Certificate of Final Plan Approval

Table with 3 columns and 6 rows containing project details: Plan Number (2025022089), Property Address (108 MOUNT VERNON AVE), County (KNOX), Date of Approval (10/25/2025), Type of Project (New Building), Governing Building Code (2024 OBC), Building / Business Name (BABE RUTH CONCESSION STAND), Description of the Project (Construction of a 560 SF seasonal concession stand with restrooms), Property Owner (CITY OF MT VERNON), Submitter (MKC Architects), Design Professional (MKC ARCHITECTS), Approved Scope of Project (General Building Trade, Mechanical, Electrical), Authorized No. of Inspections (5), Use Occupancy Groups (B), Construction Type (Type III B), Building Floor Area (560), Number of Stories (1), Building Occupant Load (7).

**Department of Commerce, Division of Industrial Compliance, Bureau of Building Code Compliance, State of Ohio
Electronic Plan Approval Sheet**

Memorial Park - Babe Ruth Concessions
City of Mount Vernon
108 Mount Vernon Ave Ext., Mt. Vernon, OH 43050

FIGURE 1
FRONT VIEW

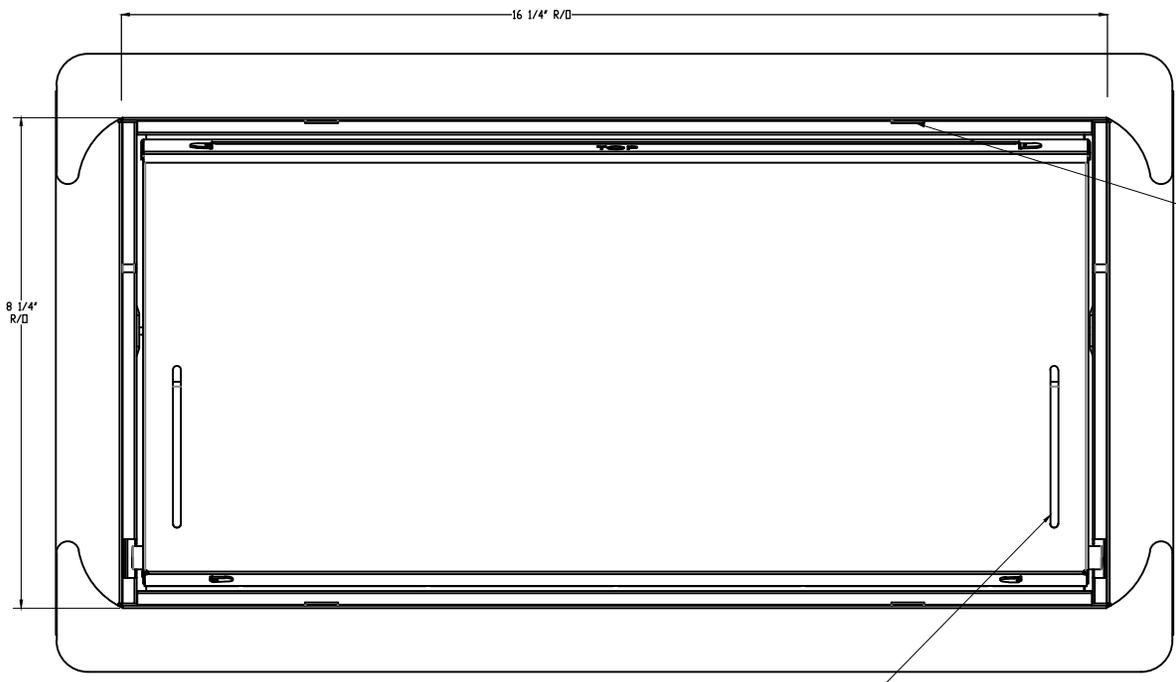
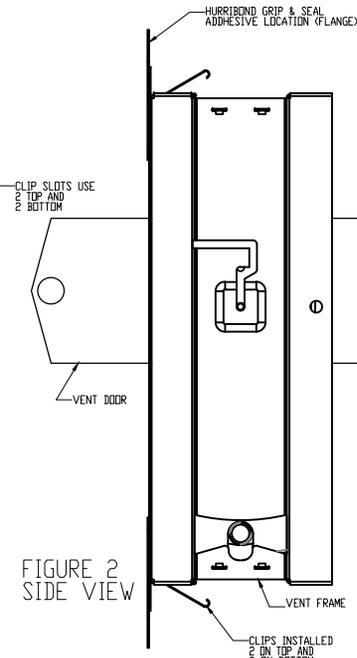
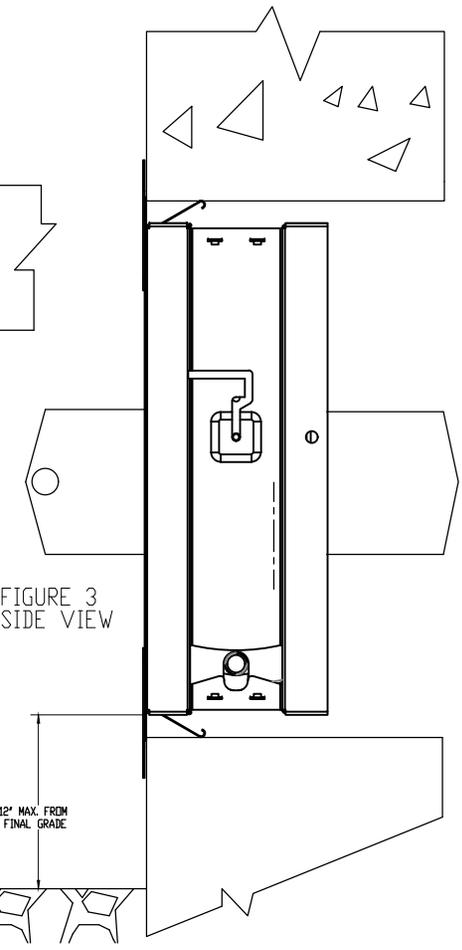
- a. The drawings indicate flood vents. Please provide the criteria for the flood vents (required opening per floor area/room, etc.)

Response: Please refer to attached Smart Vent Flood Louver cut sheets and flood opening data as provided and approved by the City of Mt. Vernon engineers.

C3 ROOF FRAMING PLAN
S101 SCALE: 1/4" = 1'-0"

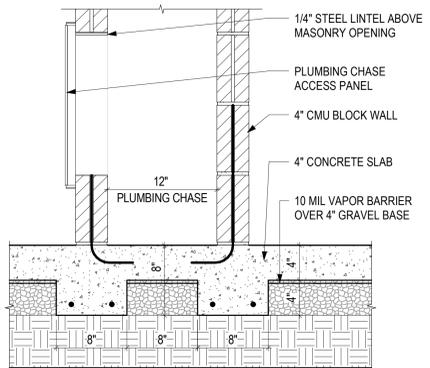
- c. As per 2024 OBC 1209.2, please provide direction on the required attic access.

Response: Attic access panels have been provided. Please refer to the roof framing plan (C3/S101) and the reflected ceiling plan (C5/A101) for locations and keynoted spec.

1 FLOOR MECHANICAL PLAN
SCALE: 3/8" = 1'-0"

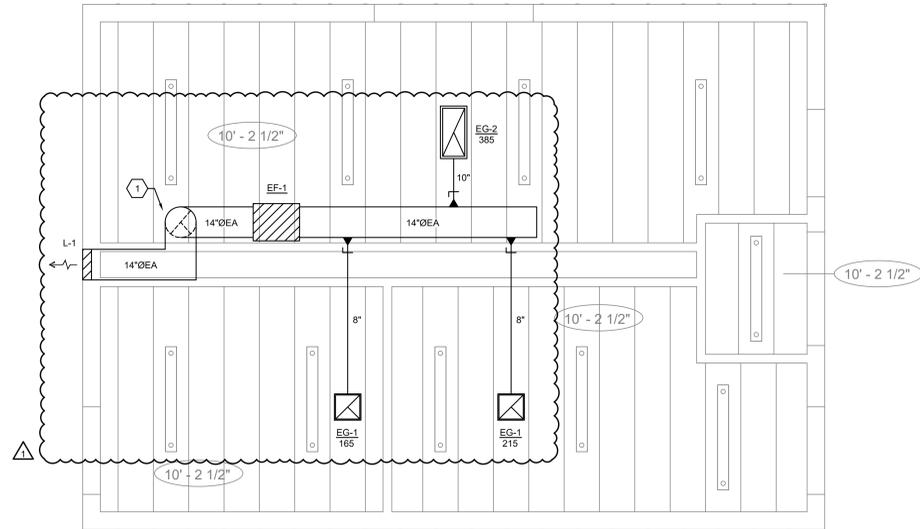
- d. As per OMC 306.5.1, please provide direction on the required platform around the roof mounted exhaust fan.

Response: The exhaust will be ducted out to a dedicated gable louver meeting required CFM.

- ROUTE EXHAUST DUCT UP INTO ATTIC AND TERMINATE WITH 14"x26" GABLE LOUVER. REFER TO ARCH PLANS FOR MORE INFORMATION. LEAVE OPPOSITE GABLE LOUVER OPEN FOR ATTIC VENTILATION. EXHAUST DUCTWORK IN ATTIC TO BE INSULATED WITH 1.5" INSULATION.

3 SINGLE LINE DIAGRAM
SCALE: NTS

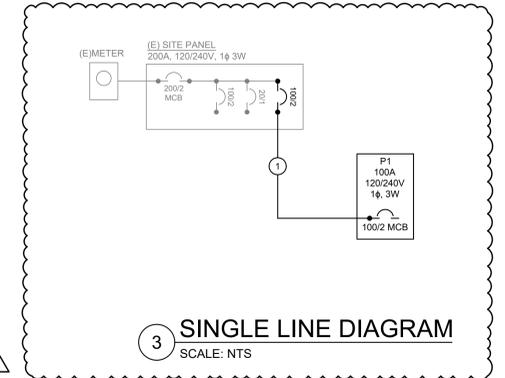
- e. Please provide a one-line diagram.

Response: Please see revised sheet E100 for one-line diagram.
